**TOWN OF NEWBURGH
PLANNING BOARD
TECHNICAL REVIEW COMMENTS**

PROJECT: MATRIX NEWBURGH, LLC
PROJECT NO.: 2016-26
PROJECT LOCATION: SECTION 95 BLOCK 1 LOT (4.12,54.1, 69.25,49.12)
REVIEW DATE: 18 APRIL 2016
MEETING DATE: 21 APRIL 2016
PROJECT REPRESENTATIVE: LANGAN ENGINEERING

Project: **MATRIX BUSINESS PARK AT NEWBURGH**
TOWN OF NEWBURGH NEW YORK
Drawing Title: **ROADWAY PROFILE AND TYPICAL SECTION**

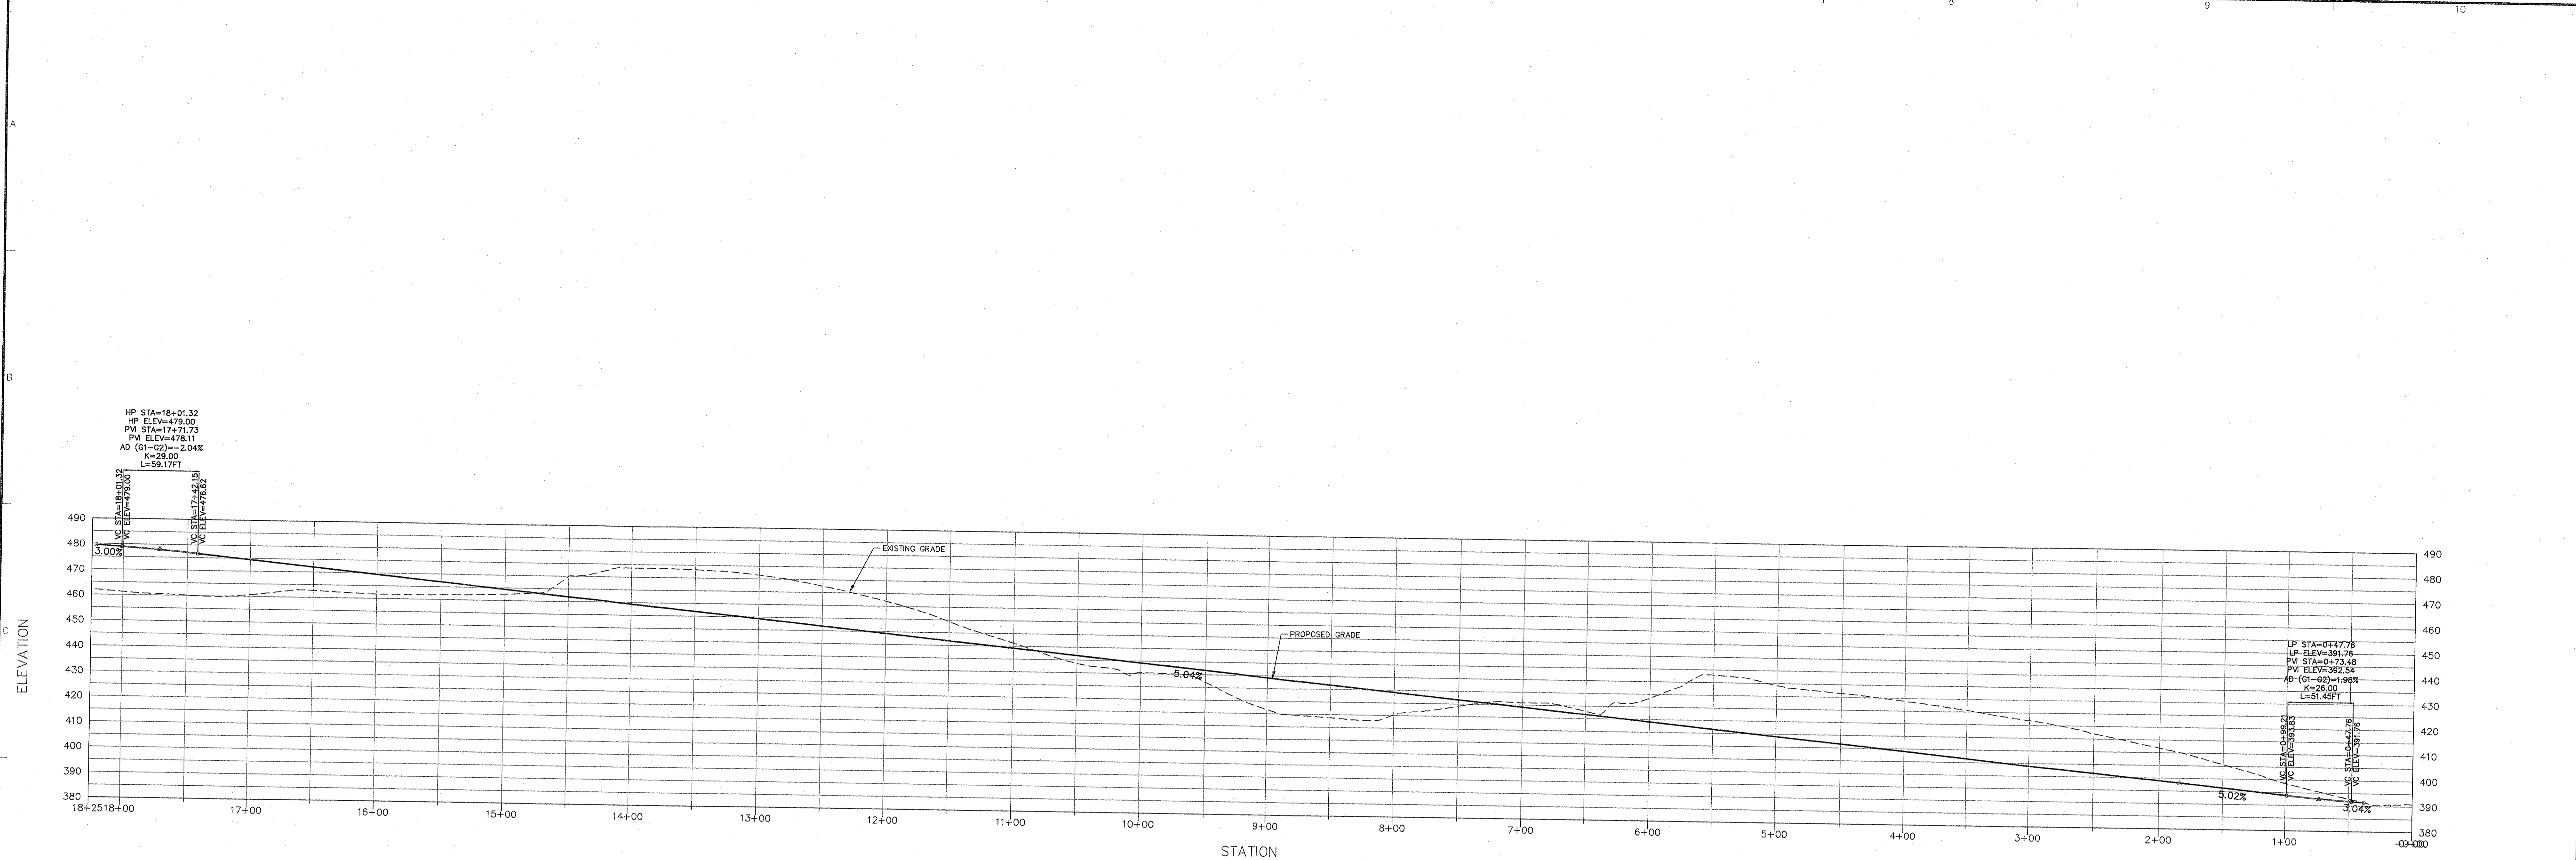
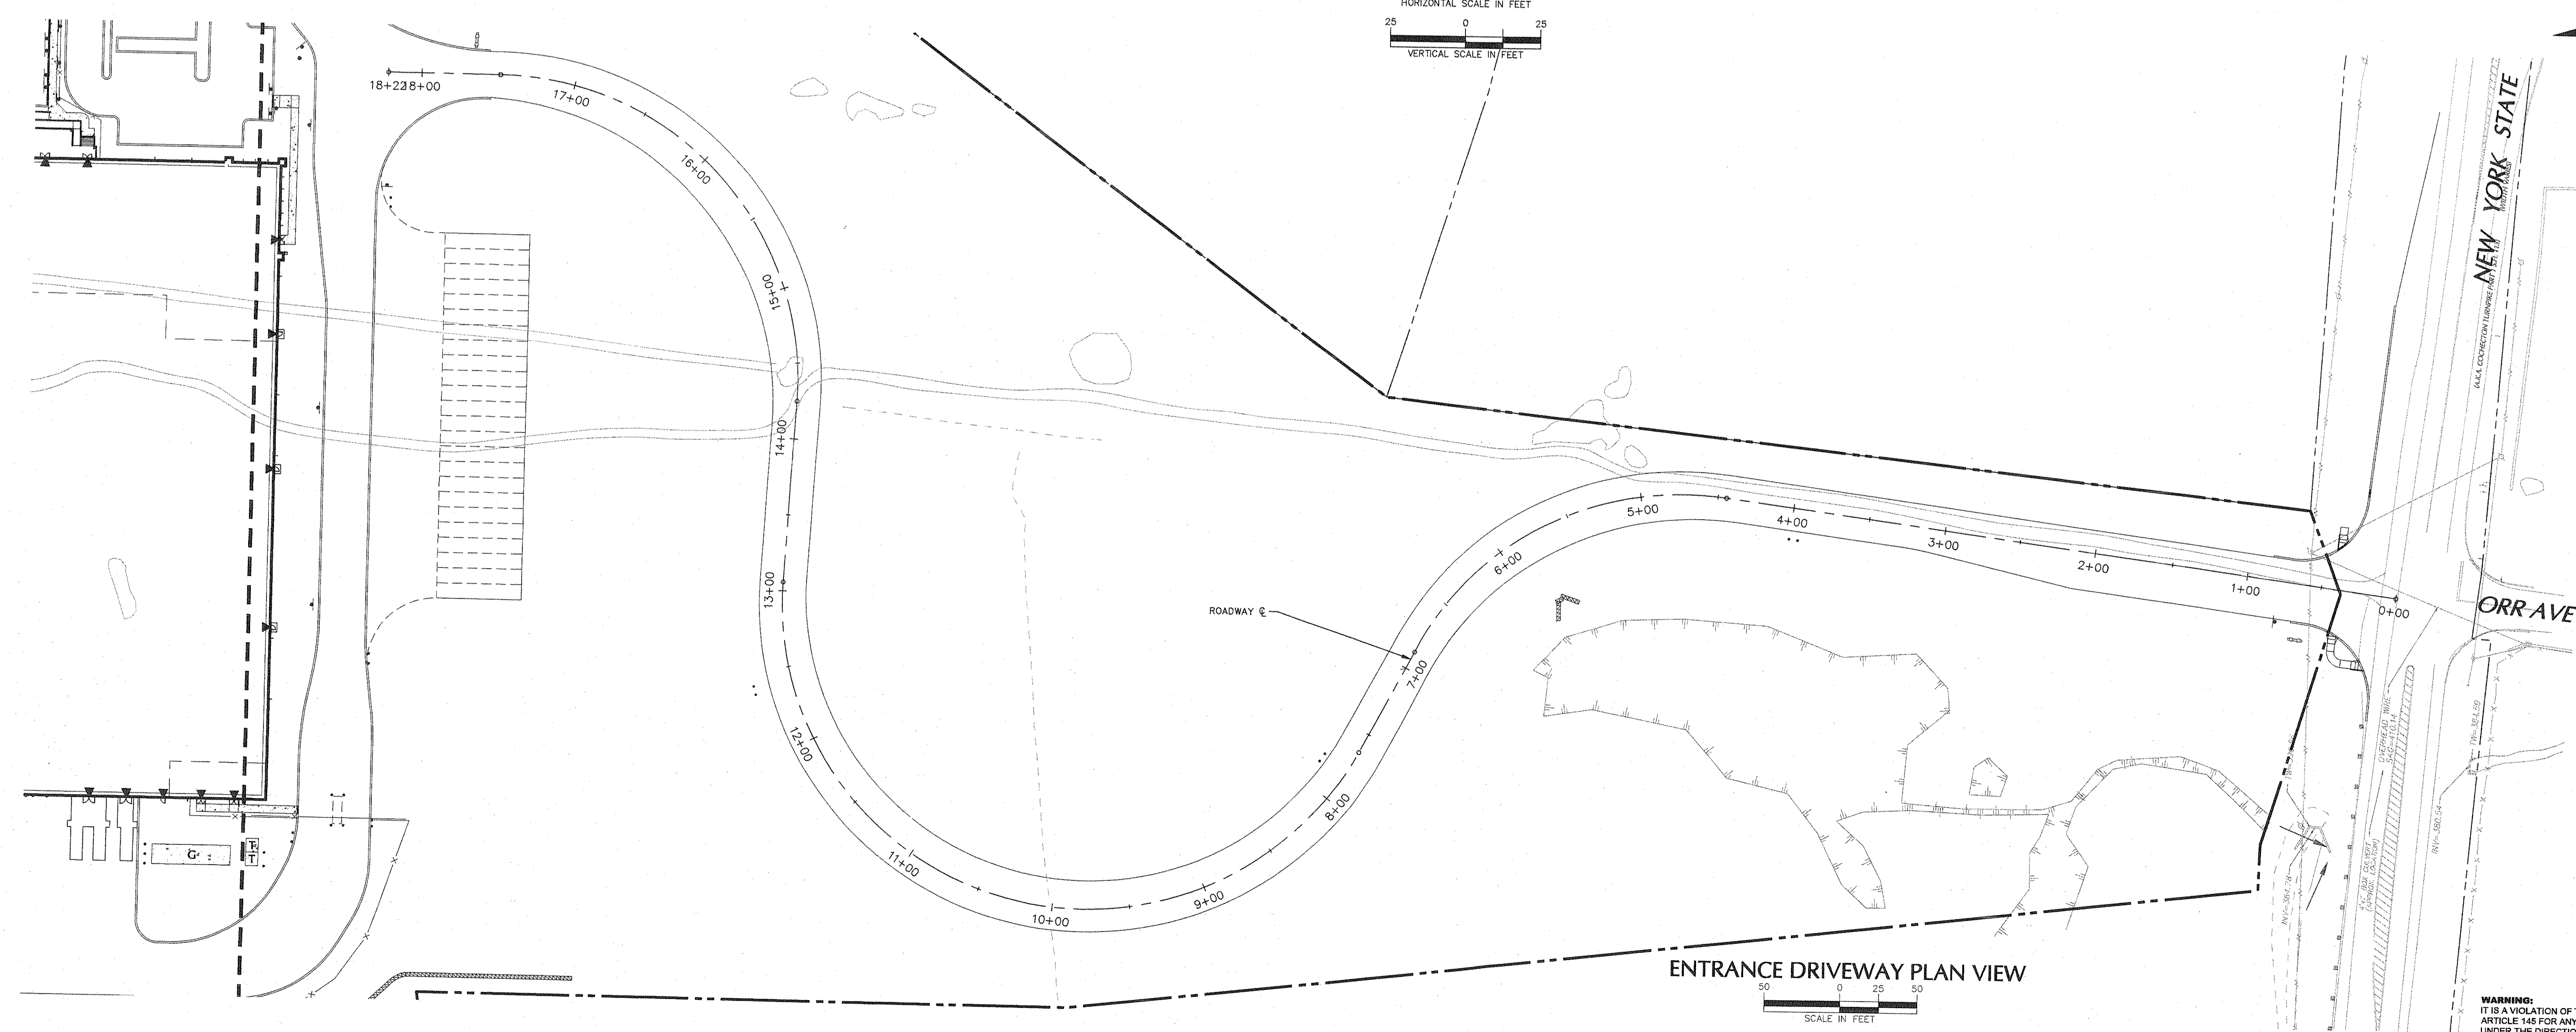
1. The Applicants are proposing to eliminate the emergency access drive to Corporate Boulevard. A mitigation plan has been provided identifying a wider access road section creating a minimum 40 foot wide drive aisle utilizing paved surfaces and expanded gravel shoulders, including truck pull off areas on the radiuses of the large turn coming off the site access road.

5. The stabilized stone shoulder pavement section should identify the manufacturer of the proposed Geo grid to be utilized below the 10 inches of stone.
